SERVICE BULLETIN

B-063

Safety Recall Code 0832

SIDESTAND ASSEMBLY REPLACEMENT FOR 2006 ULYSSES XB12X

Figure 1. Old Pivot Bolt and New Pivot Pin with Circlip

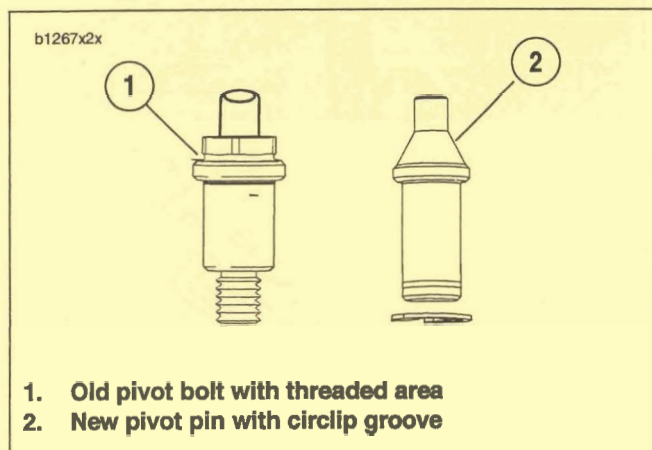
Either the pivot bolt for the sidestand leg or the mounting bracket bolts could break, possibly without notice. If either of these failures occurs, the motorcycle could fall, possibly causing death or injury.

See Figure 1. The correction for this issue is to replace the sidestand assembly and fasteners. The recall kit Part No. is 94483Y.

Figure 3. Sidestand Assembly (Extended)

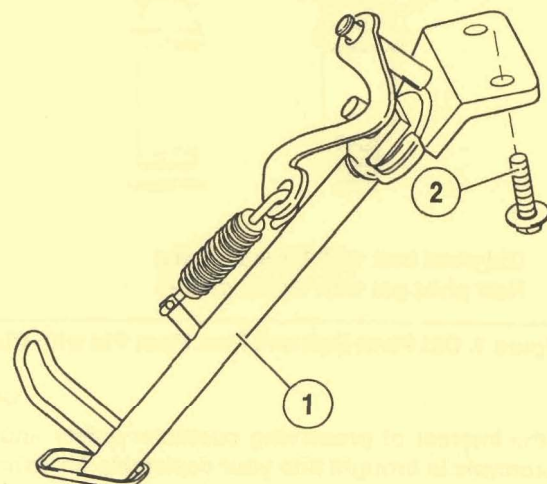
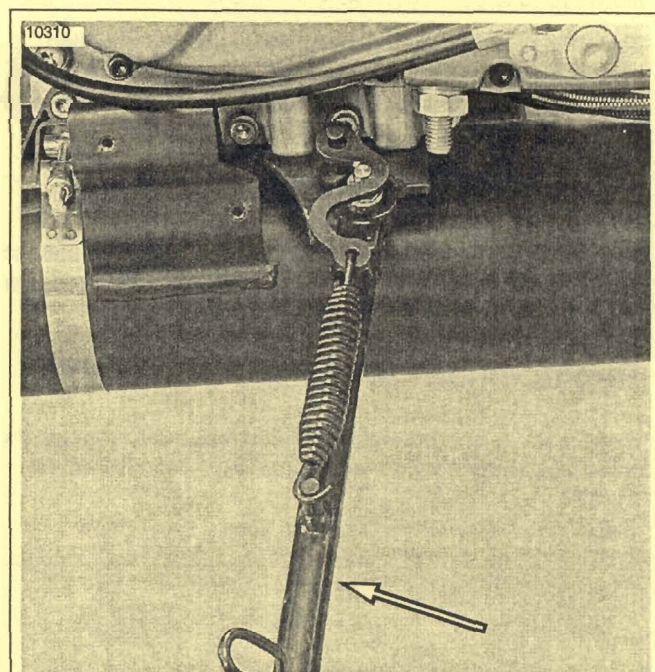
1. Place vehicle on suitable lift so it is not resting on the sidestand.
2. Remove chin fairing fasteners. See 2.38 CHIN FAIRING in Ulysses Service Manual.
3. Remove muffler. See Muffler and Straps in 2.32 EXHAUST SYSTEM in Ulysses Service Manual.
4. See Figure 3. Remove fasteners (2) securing sidestand assembly (1) to engine and remove sidestand assembly.

1. See Figure 3. Loosely install the sidestand assembly (1) to the crankcase with new sidestand bracket fasteners (2) provided in recall kit. Extend the sidestand leg (1) and hold forward in the fully extended position while tightening the sidestand bracket fasteners (2) in the following sequence:
 - a. Tighten the front fastener to 25-27 ft-lbs (34-37 Nm)
 - b. Tighten the rear fastener to 25-27 ft-lbs (34-37 Nm).
 - c. Repeat the tightening sequence in step a and b to verify proper clamp load.
2. Install muffler using new Torca clamp and front muffler strap provided in recall kit. See Muffler and Straps in 2.32 EXHAUST SYSTEM in Ulysses Service Manual.
3. Install chin fairing fasteners. See 2.38 CHIN FAIRING in Ulysses Service Manual.
4. Extend and retract sidestand leg to check for proper operation

Figure 1. Old Pivot Bolt and New Pivot Pin with Circlip

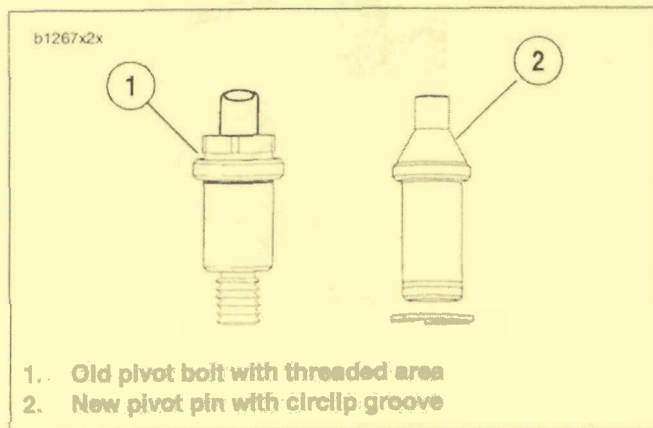
Either the pivot bolt for the sidestand leg or the mounting bracket bolts could break, possibly without notice. If either of these failures occurs, the motorcycle could fall, possibly causing death or injury.

See Figure 1. The correction for this issue is to replace the sidestand assembly and fasteners. The recall kit Part No. is 94483Y.

Figure 3. Sidestand Assembly (Extended)

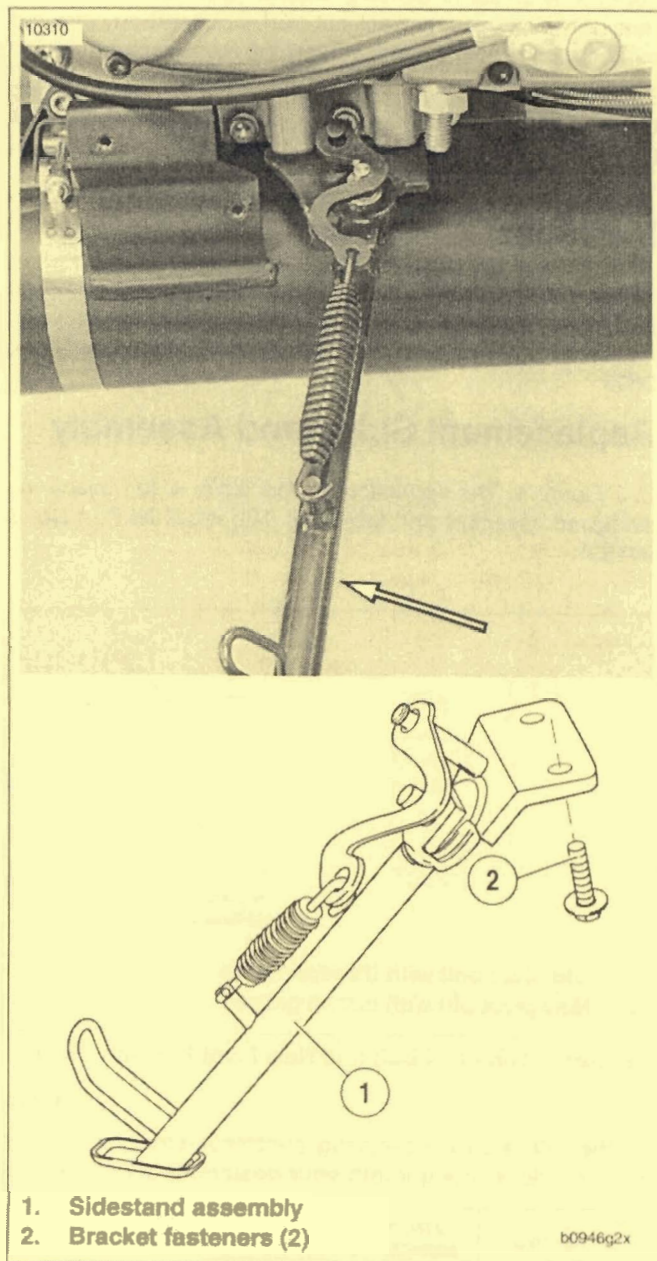
1. Place vehicle on suitable lift so it is not resting on the sidestand.
2. Remove chin fairing fasteners. See 2.38 CHIN FAIRING in Ulysses Service Manual.
3. Remove muffler. See Muffler and Straps in 2.32 EXHAUST SYSTEM in Ulysses Service Manual.
1. See Figure 3. Remove fasteners (2) securing sidestand assembly (1) to engine and remove sidestand assembly.

1. See Figure 3. Loosely install the sidestand assembly (1) to the crankcase with new sidestand bracket fasteners (2) provided in recall kit. Extend the sidestand leg (1) and hold forward in the fully extended position while tightening the sidestand bracket fasteners (2) in the following sequence:
 - a. Tighten the front fastener to 25-27 ft-lbs (34-37 Nm).
 - b. Tighten the rear fastener to 25-27 ft-lbs (34-37 Nm).
 - c. Repeat the tightening sequence in step a and b to verify proper clamp load.
2. Install muffler using new Torca clamp and front muffler strap provided in recall kit. See Muffler and Straps in 2.32 EXHAUST SYSTEM in Ulysses Service Manual.
3. Install chin fairing fasteners. See 2.38 CHIN FAIRING in Ulysses Service Manual.
4. Extend and retract sidestand leg to check for proper operation.
